**DRAFT: Review of PG&E Renewable Integration Model and CAISO 33% RPS Analysis**

Andrew Mills<sup>1</sup>, Erik Ela<sup>2</sup>, Bri-Mathias Hodge<sup>2</sup>, Brendan Kirby<sup>2</sup>, and Michael Milligan<sup>2</sup>

**December 21, 2010**

**Figure 1. The RIM approach to estimating wind forecast errors can sometimes lead to infeasible production levels that exceed the installed capacity of wind or lead to “negative” production.**

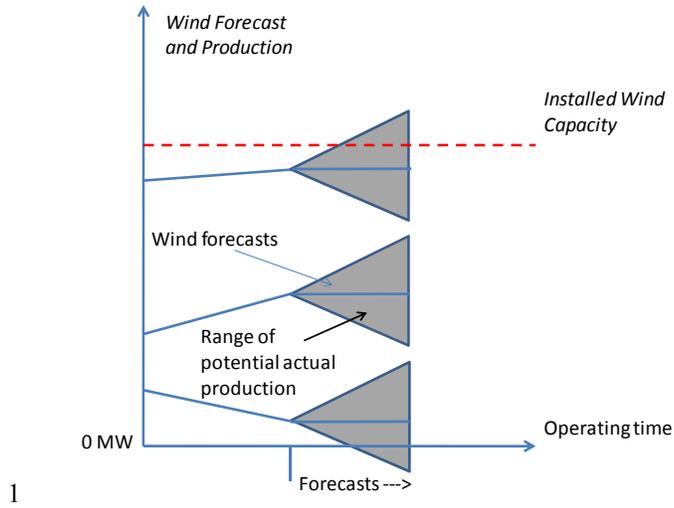
7  
8 One drawback to the seasonal variance approach used by RIM is that RIM implies that if,  
9 for example, 95% of the summer hour-ahead wind forecast errors are up to 16% of the  
10 nameplate capacity of wind,<sup>5</sup> and if reserve requirements are being set at the 95% level,  
11 then the system operator is modeled as needing to be able to accommodate an over-  
12 forecast or under-forecast of 16% of wind *nameplate capacity* in *any* hour of the summer  
13 (Figure 1). However, if wind production is forecasted to be only 10% of the nameplate  
14 capacity of wind during a particular summer hour with high load, it is not physically  
15 possible to have an over-forecast of 16% of wind (at most the over-forecast can be 10%  
16 of nameplate if the actual wind output were to drop to zero). A way to correct for this is  
17 to have the load following requirement in RIM depend on variable renewable production

**Figure 2. The CAISO methodology for translating forecast errors into load following requirements in Step 1 truncates the range of forecast errors to ensure all levels of forecasted production are feasible.**

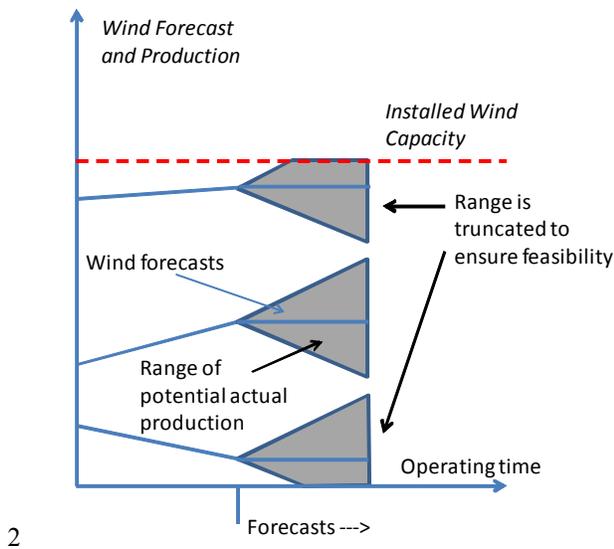
5 In contrast, the CAISO approach uses the variance to define the spread of an assumed  
6 truncated normal distribution for the uncertainty of the load and variable renewable  
7 resources. The CAISO approach truncates the distribution of forecast errors to either 3  
8 standard deviations from zero or in a way that it ensures that any forecast error could  
9 physically occur (meaning that the CAISO approach checks that wind and solar  
10 generation could actually reach production levels that generate any particular forecast  
11 error), Figure 2 (Makarov et al., 2009; CAISO, 2010 page 48). Following from the  
12 previous example regarding forecast errors for RIM, the CAISO approach would truncate  
13 the possible hour-ahead forecast errors to 10% on wind nameplate capacity if the hour  
14 ahead forecast was for wind to generate at 10% of its nameplate capacity (instead of  
15 allowing it to be greater than 10% like RIM would do).

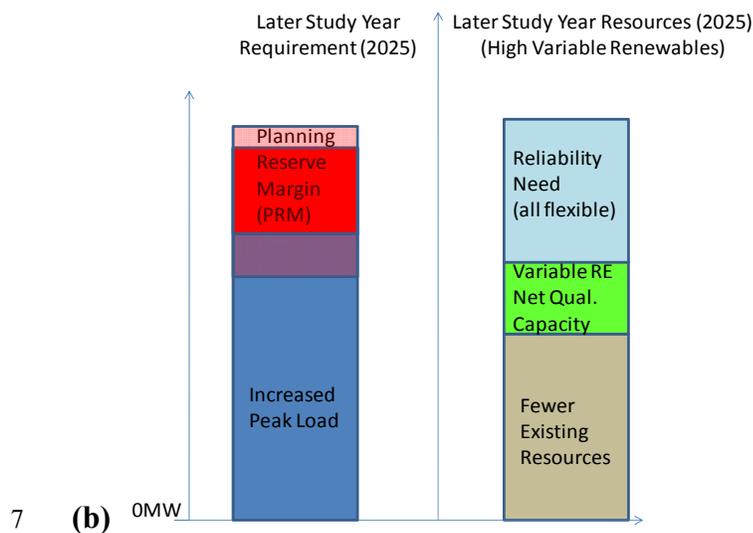
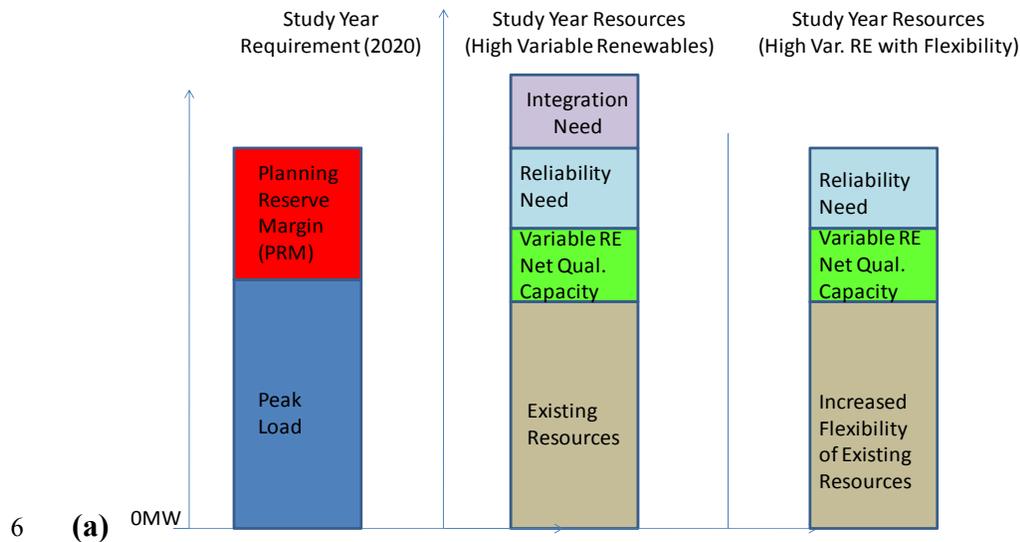
1 more flexible might be sufficient to reduce the violations observed in the CAISO analysis  
 2 (and therefore reduce the integration capacity need) by (Figure 7a). Or alternatively, the  
 3 units that are added for integration capacity need in the study year may contribute to the  
 4 “reliability need” in future years with load growth and/or retirements of existing units  
 5 (Figure 7b).

2 Given the innovativeness of the approach used in the California studies, it is worthwhile  
3 to carefully understand the implications of the violations observed in the production cost  
4 model and potential alternative methods for dealing with the violations. CAISO can use  
5 a sensitivity study with increased flexibility of the existing and planned units and the 33%  
6 reference portfolio to evaluate the potential for increased flexibility of existing units to  
7 avoid the need for new flexible capacity (Figure 7a). CAISO can also examine a  
8 sensitivity study of increased load to 2025 levels, but the exact same resources as used in  
9 the 2020 case for the 33% reference case, to determine if units built for "integration  
10 need" not only add flexibility to the system but also enable it to meet increased future  
11 loads (Figure 7b). These sensitivity studies should be easy to implement and would aid in

<b>CAISO</b>	Evaluate ability of units built in study year (2020) for “integration need” to contribute to “reliability need” in future years (e.g. 2025) (Figure 7b)	Low	Develop additional sensitivity scenarios to evaluate relative to the reference case.	If new units are needed to increase overall system flexibility, the same units may also help meet future load growth. Use system that addresses all violations in 2020 but increases the load to 2025 levels in sensitivity study to determine if the 2020 system is adequate to also meet increased loads

**Figure 9. Change in net load with increasing CSP penetration (assuming no within hour variability and forecast error for CSP).**

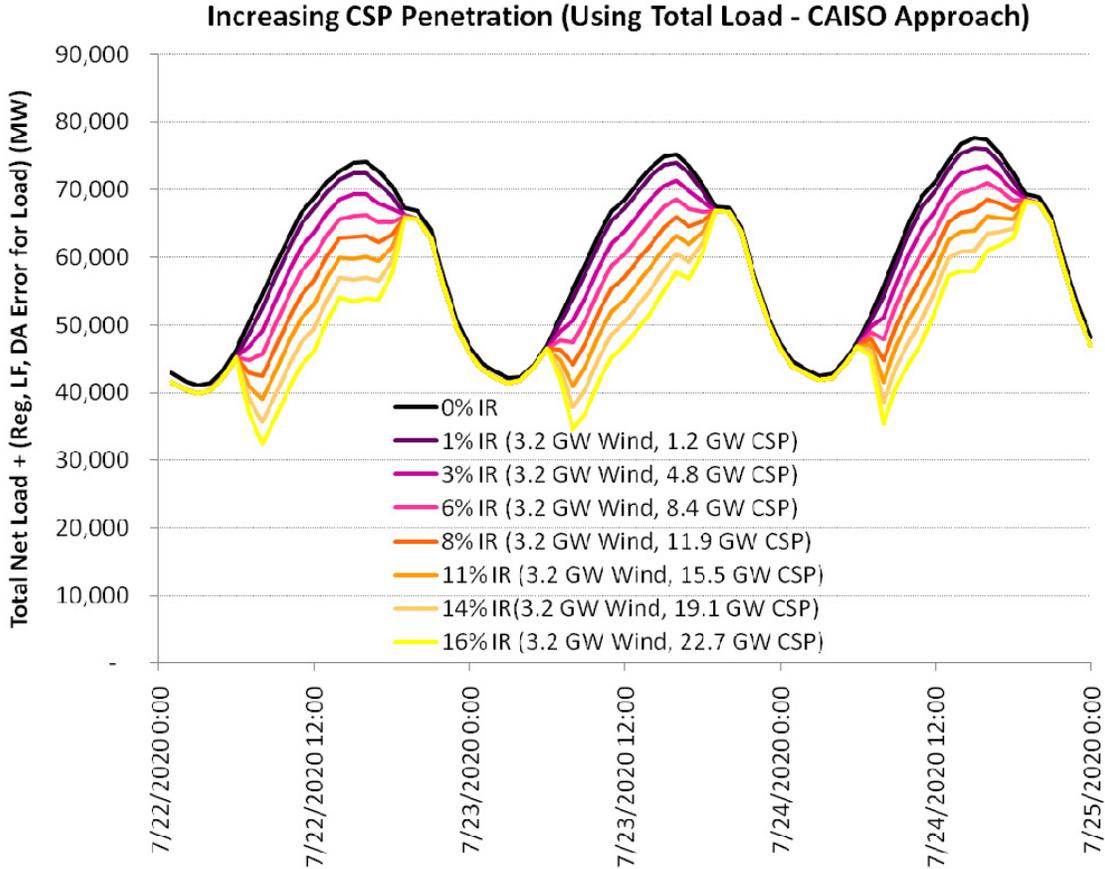
6 At issue is that the current NQC approach used by the CPUC focuses on variable  
7 generation during peak load periods. The underlying assumption is that if a variable  
8 generator is expected to consistently generate power during peak load periods it will  
9 contribute to meeting demand and some fraction of the variable generator can count  
10 toward the planning reserve margin. The problem is that as the penetration of variable  
11 generation increases, the period in which generation capacity is scarce will shift from  
12 periods of peak load to periods of peak net load. This is more obvious in the case of solar  
13 generation. Under the current NQC methodology solar generation receives a high NQC  
14 due to its high output during summer afternoon peak load periods. As the penetration of  
15 solar increases, however, there will be ample generation during summer afternoon peak  
16 load periods, but solar will not reduce the load during summer early evenings after the

17 sun goes down. At high solar penetration levels, the high net load period will become the  
18 critical hour and increasing solar capacity will not reduce the summer evening load. This  
19 issue is clearly illustrated in Figure 9 which shows the total load plus operational flexibility  
20 requirements for the load minus the hourly generation from a renewable resource  
21 portfolio with increasing CSP.<sup>35</sup> The peak load occurs on the afternoon of July 24<sup>th</sup>. CSP

7 Therefore at high solar penetration levels, the current NQC methodology will continue to  
 8 assign a high capacity credit to CSP even though additional CSP plants are no longer  
 9 contributing to the reduction in net load during the new critical (highest net load) period.

**Figure 10. Comparison of expected reduction in peak net load based on NQC methodology (marker filled in) to the actual measured peak hourly net load (marker open) for increasing penetrations of each variable renewable technology.**

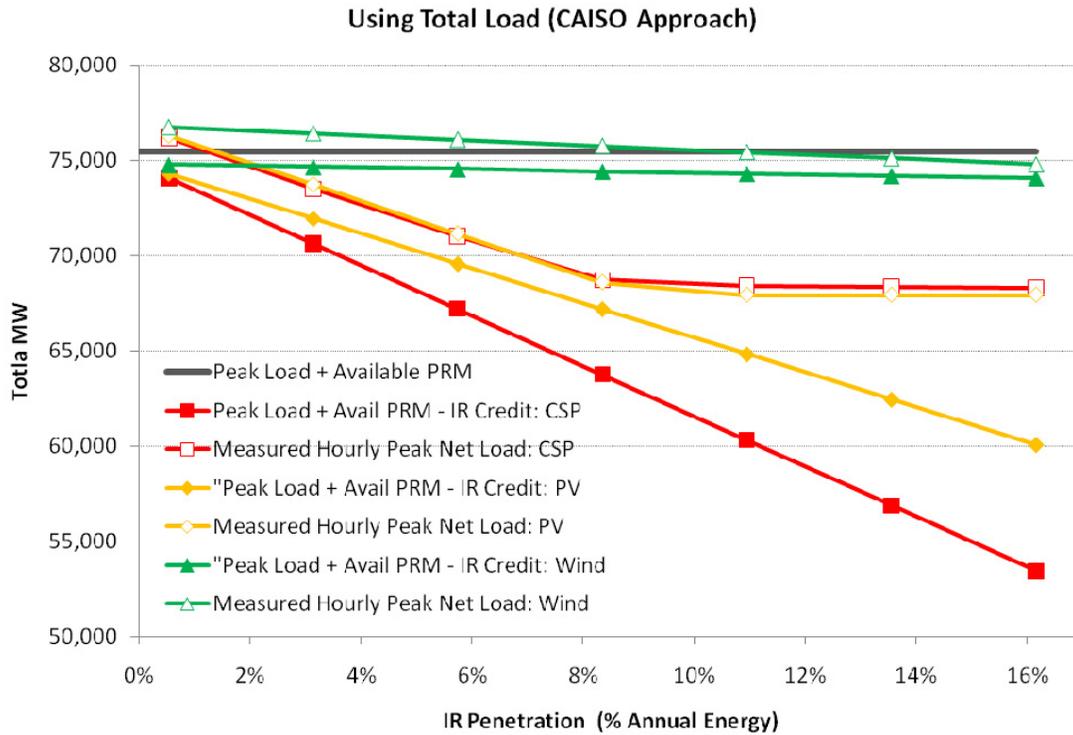
1 This discrepancy between what is implied by the NQC methodology and what is actually  
 2 measured in the reduction in the peak hourly net load is illustrated for each technology  
 3 (PV, CSP, and New Wind) in Figure 10.

5 The NQC of a variable renewable resource estimates the amount that the capacity needed  
 6 to meet the peak load plus available planning reserve margin is reduced by the addition of  
 7 a variable renewable generator (as shown by the filled in markers in Figure 10). The high  
 8 NQC of CSP (the NQC used for CSP in RIM is ~96%) drives this requirement down very  
 9 rapidly with increasing penetration of CSP. The actual reduction in the peak hourly net  
 10 load plus operating flexibility requirements for the load (open markers in Figure 10)  
 11 follows the same trend at low penetration of CSP, but after the penetration of CSP

12 Overall, at very high penetrations of solar (>12-13 GW of nameplate capacity, or just  
13 above the level of solar included in the 33% Reference case from RIM) the difference  
14 between the capacity credit assigned by the NQC methodology and the actual reduction  
15 in peak hourly net load will begin to diverge. Since the NQC overstates the ability of  
16 solar to reduce the net load at very high solar penetration, this discrepancy will appear in  
17 the analysis as driving an increase in “integration need” (since more conventional  
18 capacity will be needed to meet load than estimated by the NQC method). The  
19 “integration need” estimated in the CAISO analysis may be slightly affected by this  
20 discrepancy in the 33% reference case, but it is expected to have a more noticeable and  
21 substantial impact for cases with solar penetrations greater than in the 33% reference  
22 case.

**Figure 12. Comparison of expected reduction in peak net incremental load based on NQC methodology (marker filled in) to the actual measured peak hourly net incremental load (marker open) for increasing penetrations of each variable renewable technology.**

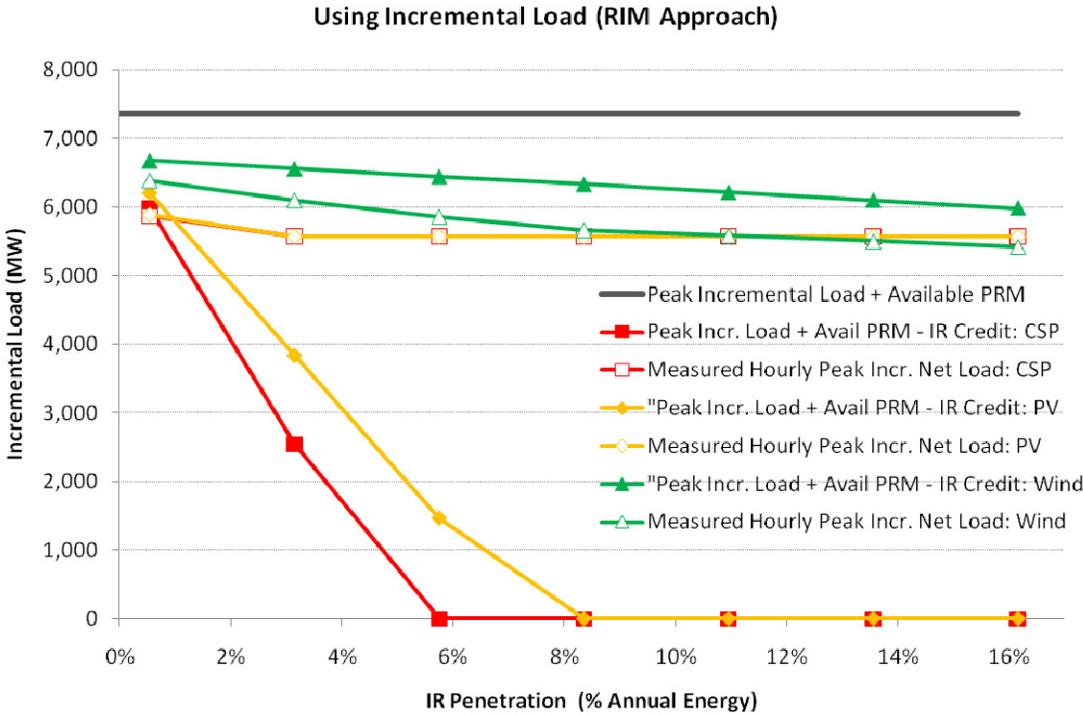
1 methodology and the measured reduction in the peak hourly net incremental load. Figure  
 2 12 demonstrates that with ~5 GW of solar (3% IR penetration) there is already a 2-3 GW  
 3 difference between the load reduction capability implied by the NQC methodology and  
 4 the reduction in the peak hourly net incremental load. By 12-13 GW of solar (8 %  
 5 penetration) the gap increases to nearly 6 GW. This 6 GW difference will appear in the  
 6 RIM model as “integration need” even though the source of the additional conventional  
 7 capacity is a mismatch between the NQC methodology and the measured reduction in the  
 8 peak hourly net incremental load.

6 **Figure B.1. 2020 load on July 7-28<sup>th</sup>**

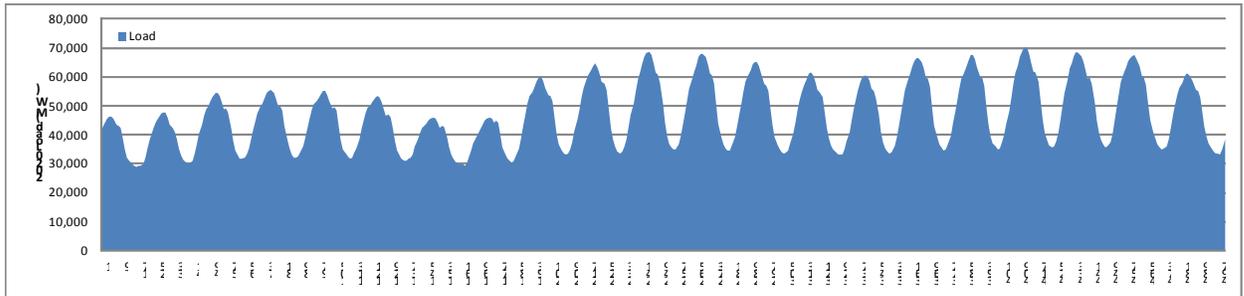
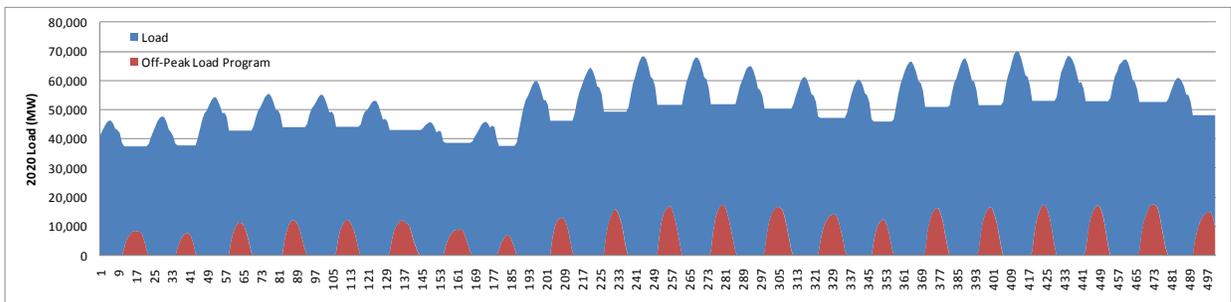
10 One would expect that there should not be any sort of "integration cost" associated with a  
11 program that increases off-peak load. In fact, increasing off peak load would increase the  
12 utilization of mid-merit units and has often been seen as an overall benefit to the  
13 economics of utilities. If one replaces the New Wind IR profile (located in the "IR2" tab)  
14 with a "negative generator" or load that increases off-peak consumption (and sets the  
15 variability and uncertainty parameters for New Wind to zero), the RIM model should  
16 calculate a zero integration cost associated with this increased off-peak load (see Figure  
17 B.1-2).

2 The high integration cost is due to RIM not allowing existing units in 2008 to increase  
3 their output to meet the increased off-peak load in 2020. Instead RIM requires new CT's  
4 and CCGT's to be built just to meet these incremental off-peak loads.
